Subject: **Response to On Hold Letter** for request for Section 401 Water Quality Certification Modification, Wilmington Bypass from north of US 74/76 in Brunswick County to US 421 in New Hanover County. DWQ Project No. 10-0867v.4. TIP R-2633B.

Reference: NCDOT Modification Request, dated April 3, 2013
NCDWQ On Hold Letter, dated April 19, 2013, received April 26, 2013

Subject: Request for Modification to Individual Section 404 and Section 401 Water Quality Certification for the Wilmington Bypass from north of US 74/76 in Brunswick County to US 421 in New Hanover County. Federal Aid Project Nos. NHF-0017 (96) and STM-0017(97), WBS No. 34491.2.3, TIP No. R-2633B, DWQ Project No. 10-0867v.4

WETLAND CROSS SECTION
SITE 6B

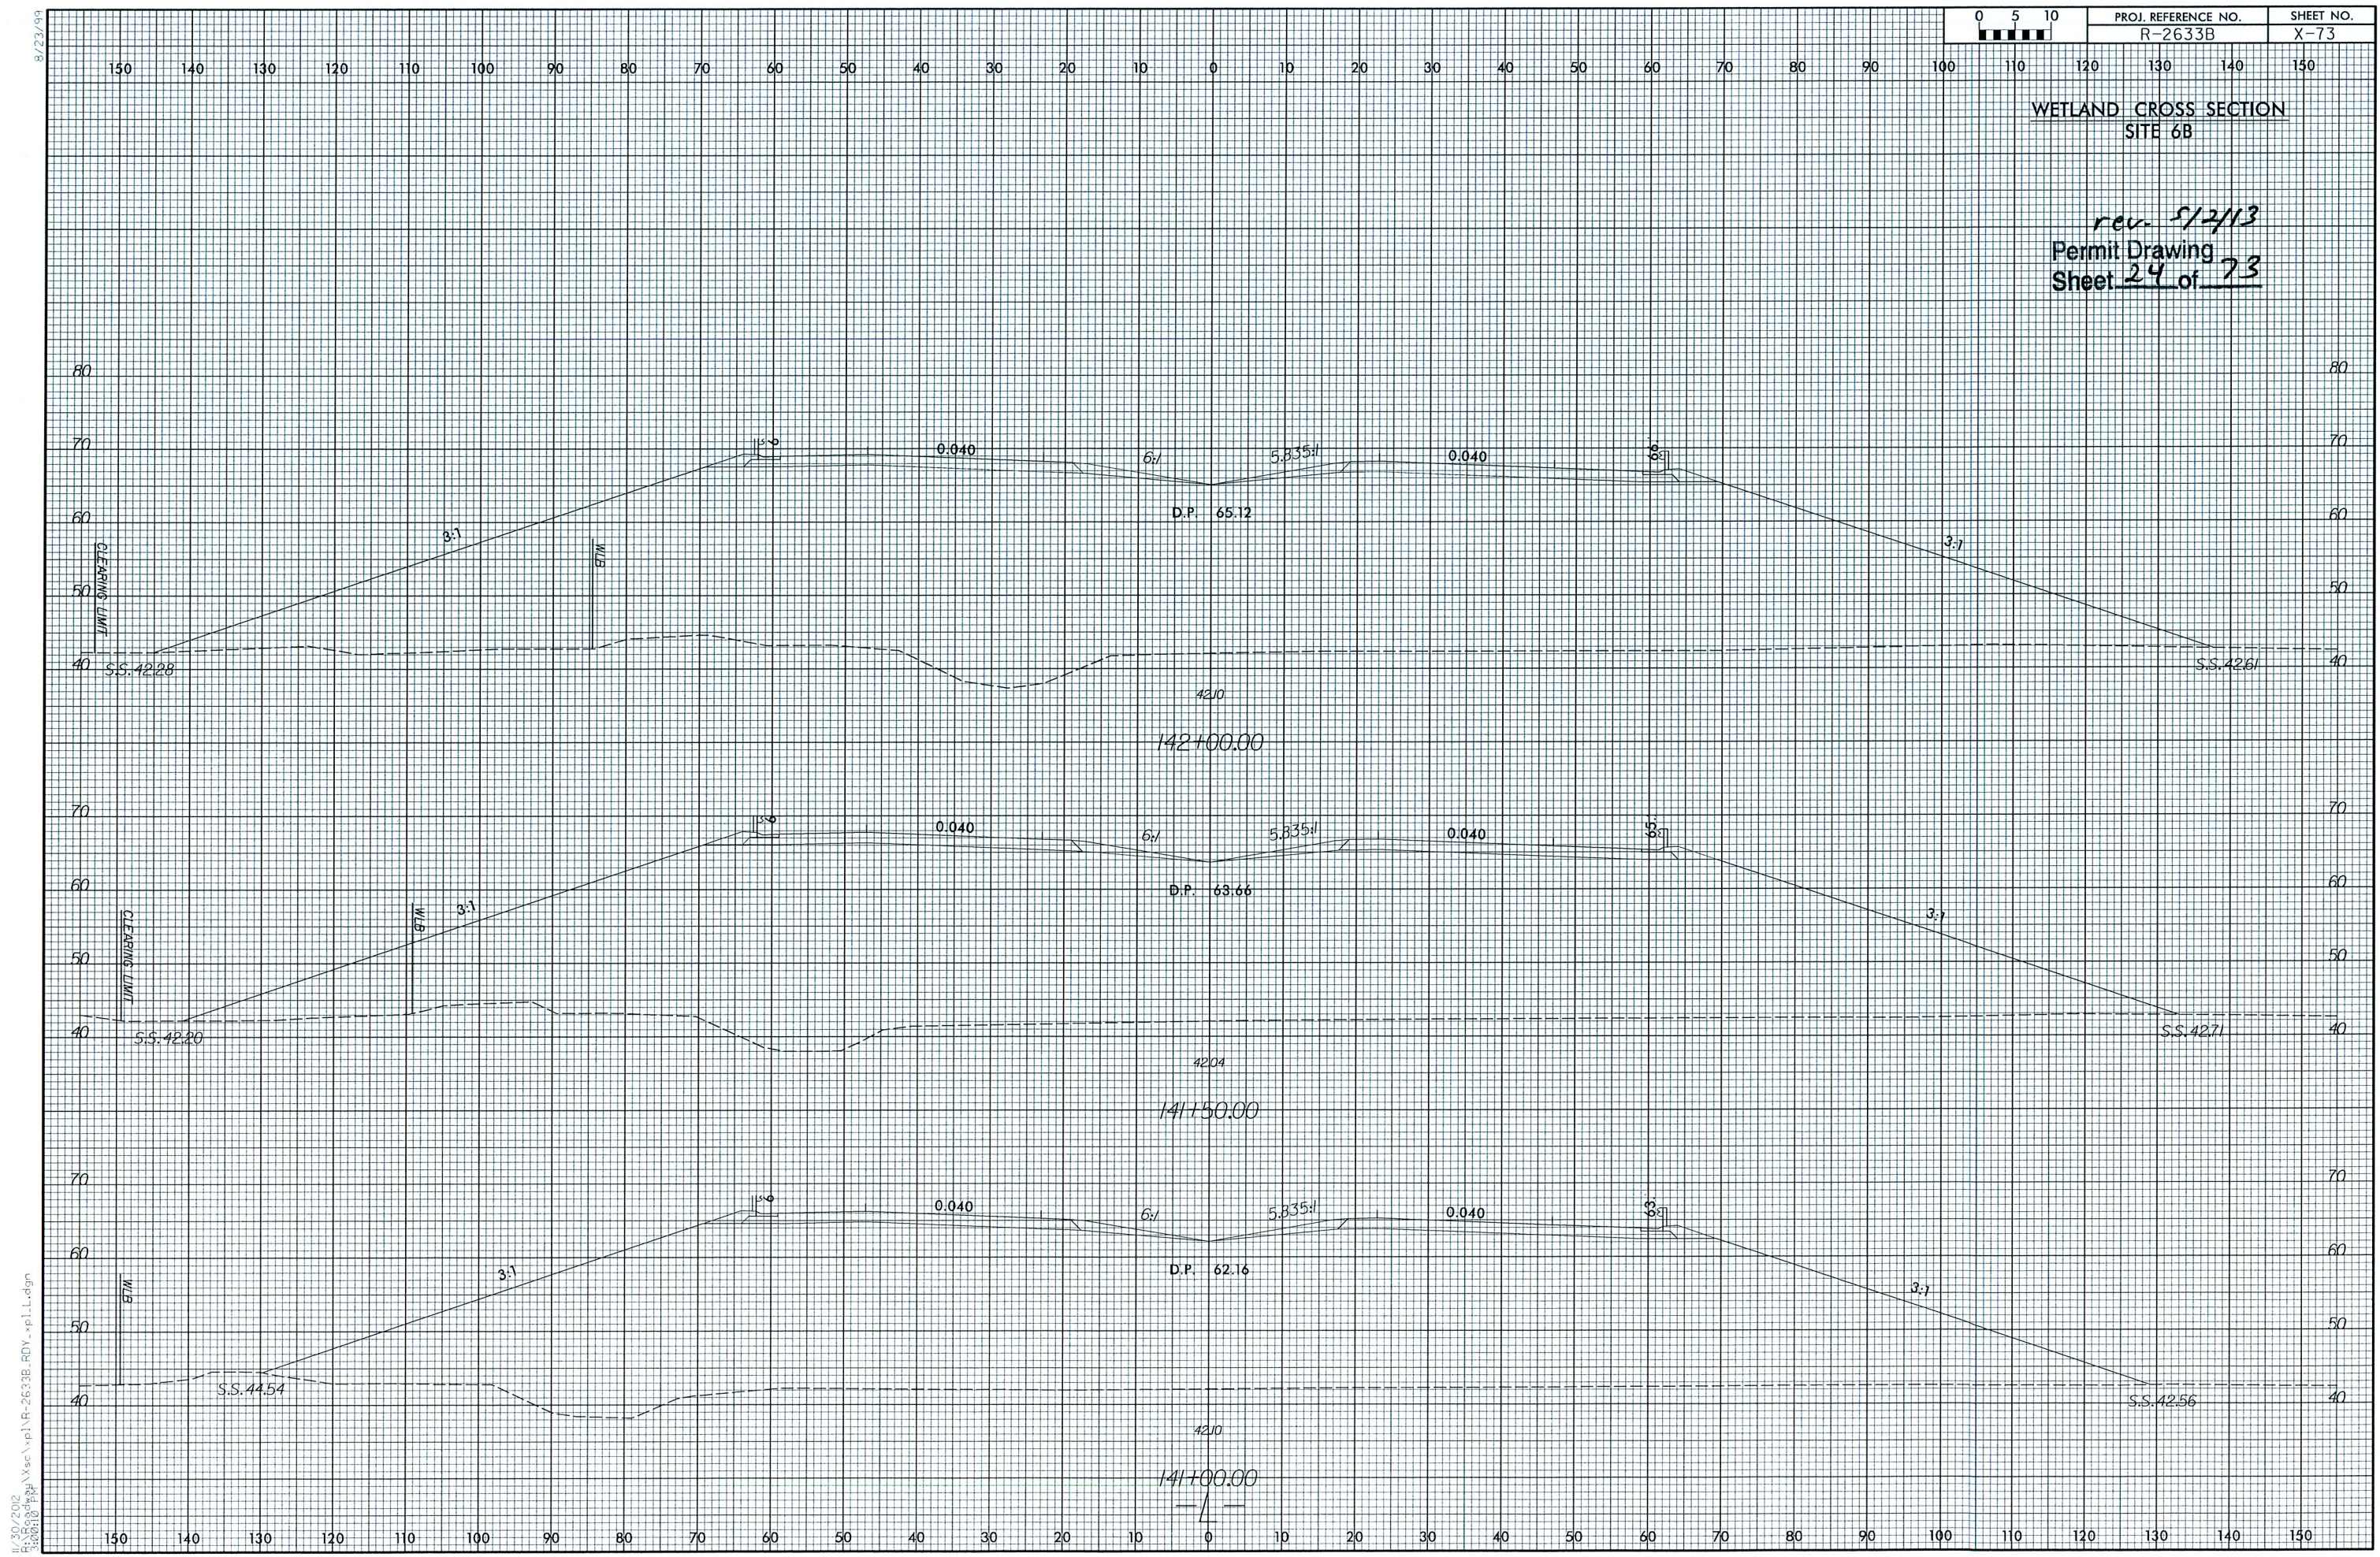
3. Your application states in the "Avoidance and Minimization" section that 3:1 slopes will be used in wetland areas to minimize wetland impacts. Upon review of the application there are several cross sections that show greater than 3:1 slopes. Please correct.

Sites 3, 5 & 6 permit drawings, cross sections, and impact summary sheet have been revised and are enclosed. As a result, proposed permanent fill has decreased at these sites by 1.42 acres. Additionally, we will submit a revised request to EEP for an updated acceptance letter.

rev. 5/2/73
Permit Drawing
Sheet 28 of 73

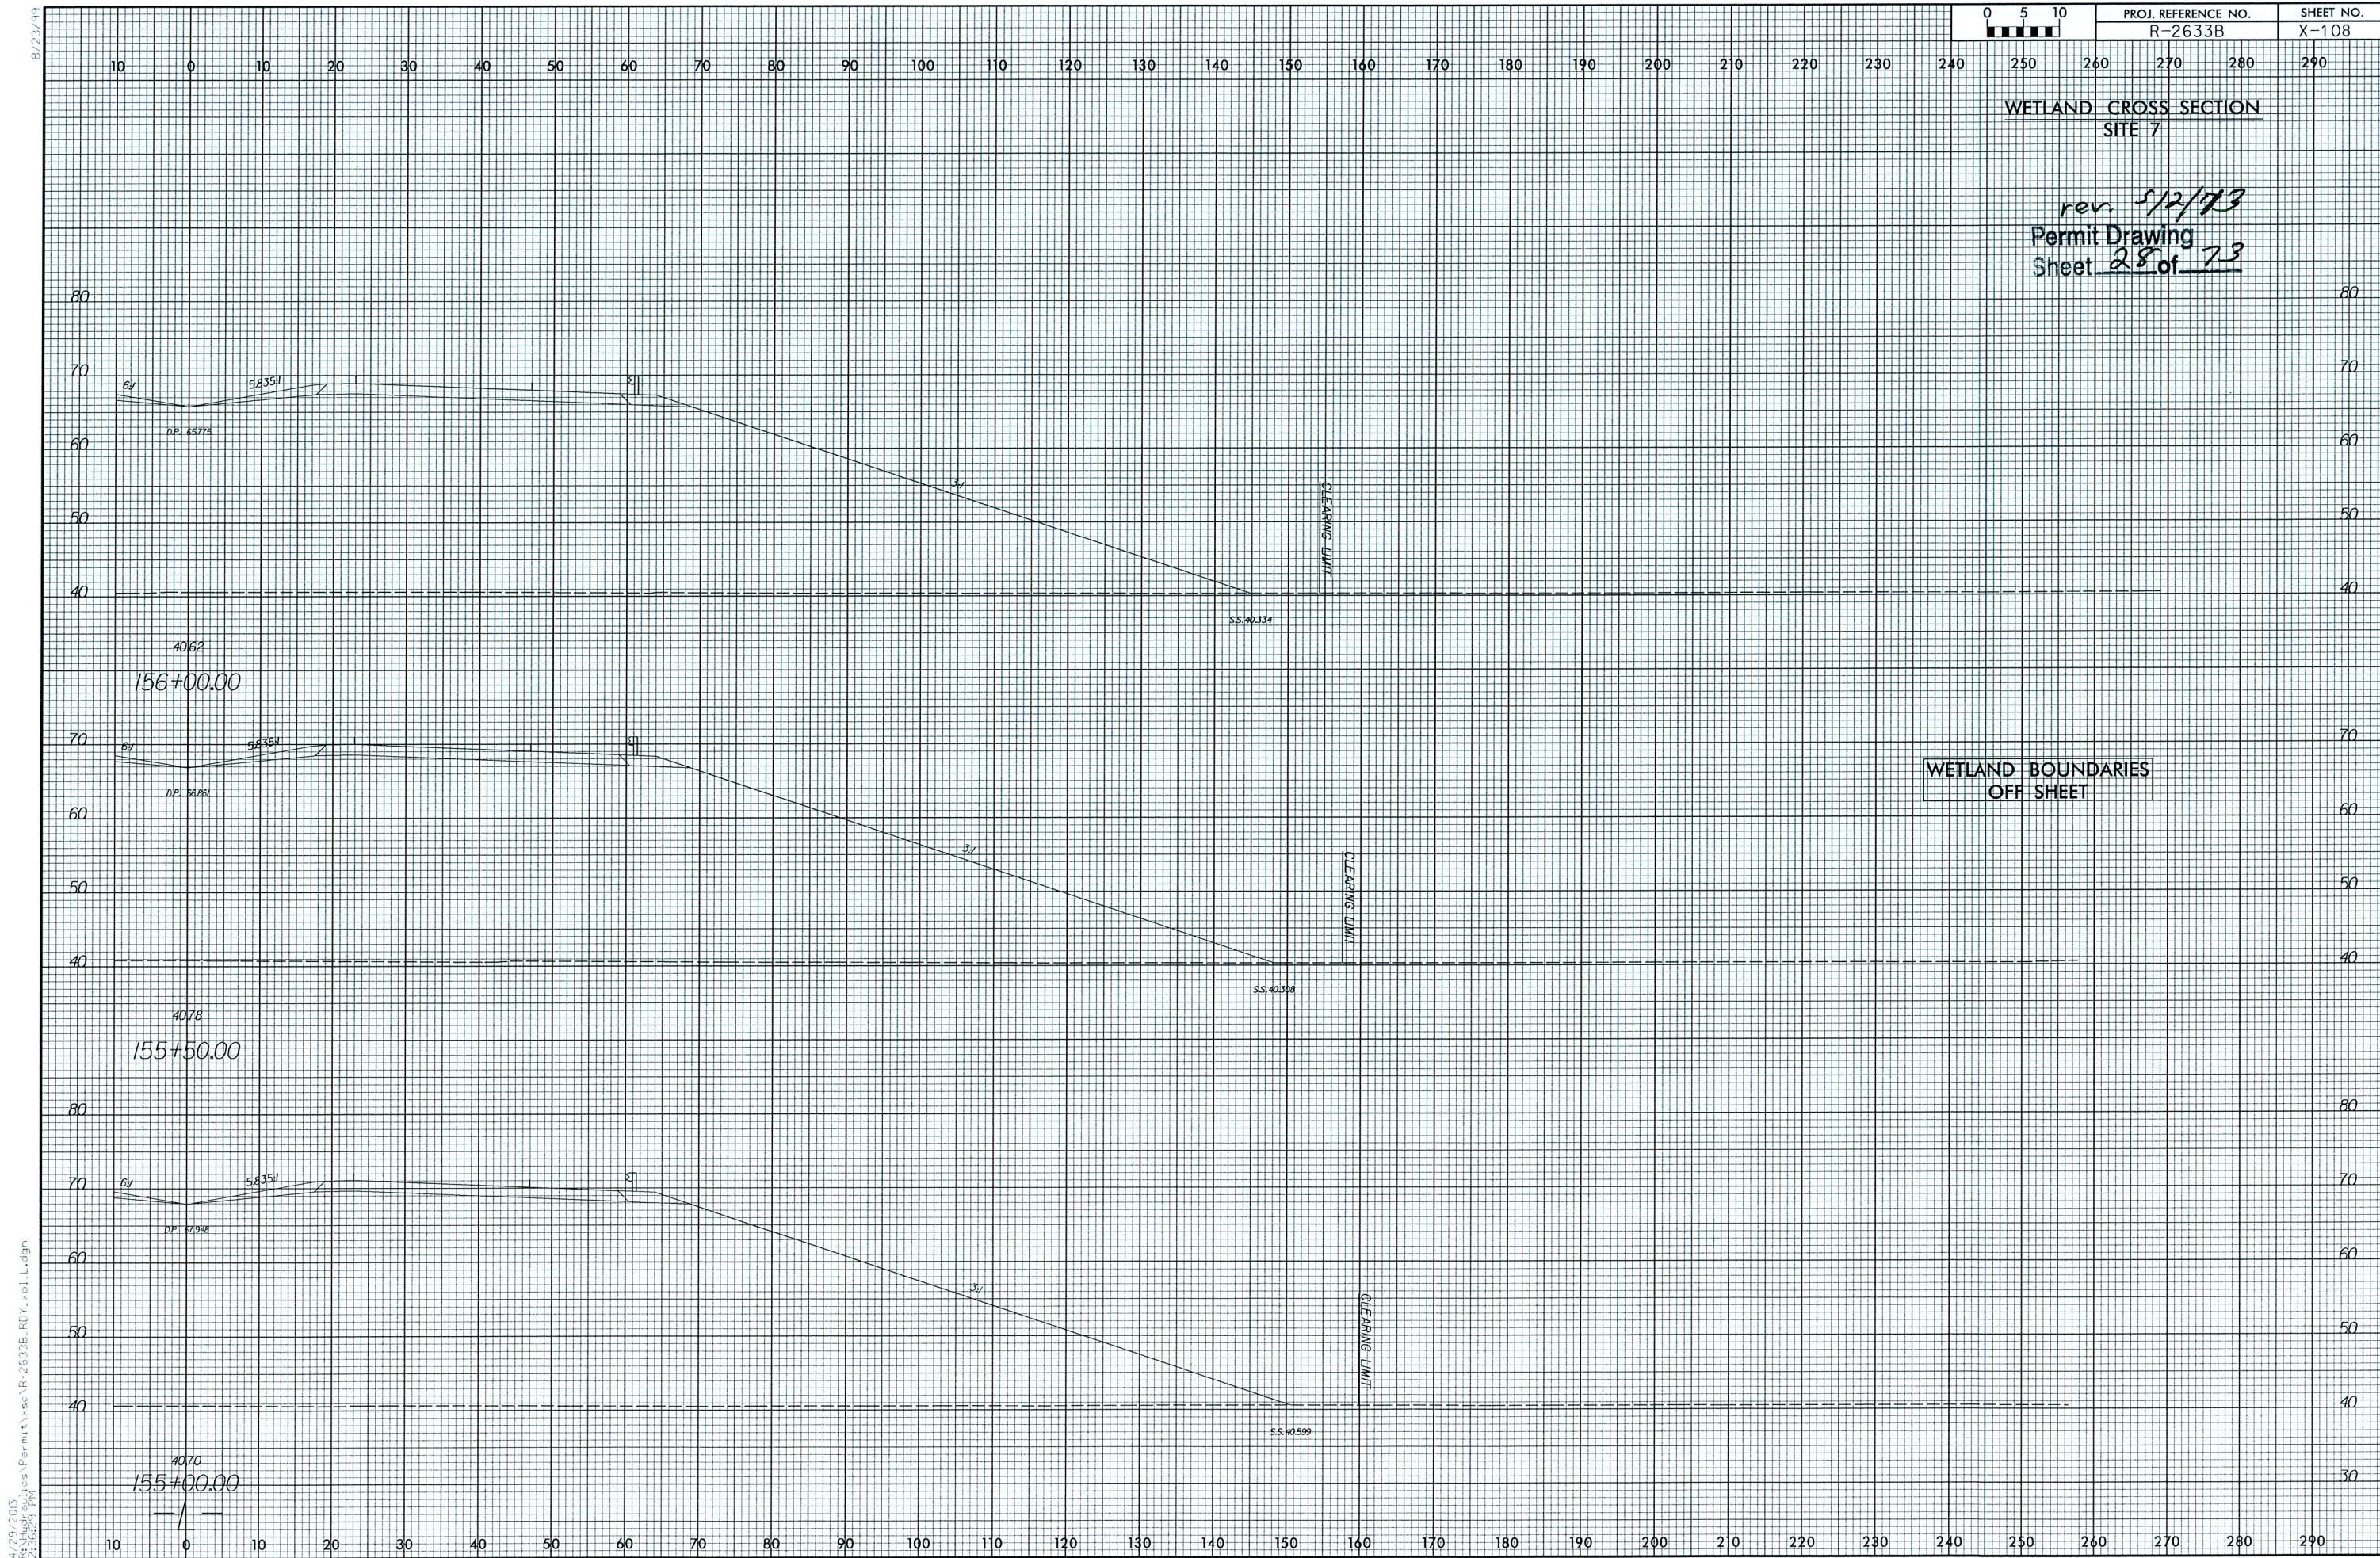
4. *Site 7 (permit drawings 27/28), a wetland boundary limit is shown on the cross sections beyond the clearing limits however the plan sheets show that the entire right of way is within the wetland. Please clarify.*

4. Site 7 (permit drawings 27 /28), a wetland boundary limit is shown on the cross sections beyond the clearing limits however the plan sheets show that the entire right of way is within the wetland. Please clarify.

The wetland boundary limits are outside of the fill slopes. A note has been added to the cross sections. Revised sheets for Site 7 (Permit drawings 27 and 28) are enclosed.
